AMENDMENTS TO THE DRAWINGS:

REDLINE SHEET

Inventor(s):aph Indhiran Vanniasinkam Application : 10/764,979
Title: OPTICAL ROSA FOR LONG REACH OPTICAL TRANSCEIVER

FIG. 1

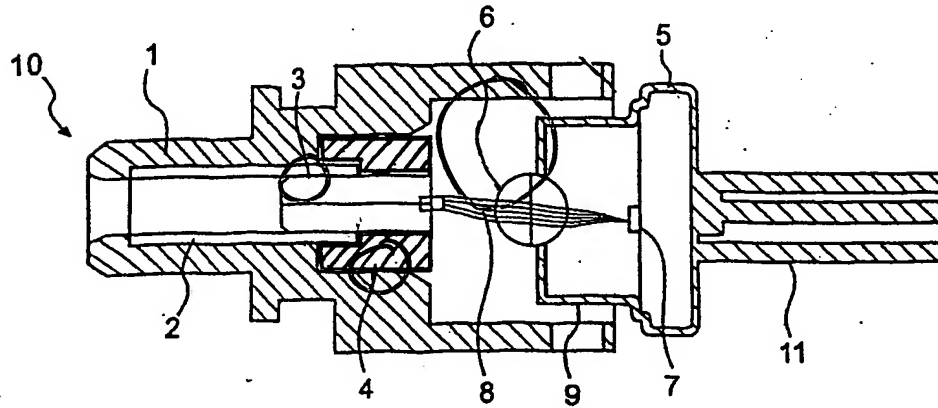
Applicants amend Fig. 1 to be more consistent with the other Figures. In particular, Applicants amend Fig. 1 to properly include the stub holder 4 as shown in Fig. 2 and described in the specification at page 6, paragraph 19 and page 7, paragraph 21. Further, Applicants amend Fig. 1 to properly indicate that lens system 6 should point to the circular lens as shown in Figs 2 and 5B. Furthermore, Applicants amend Fig. 1 to clarify that item 3 points to the fiber stub and not the core of the fiber stub, which is consistent with Figs. 3 and 5A.
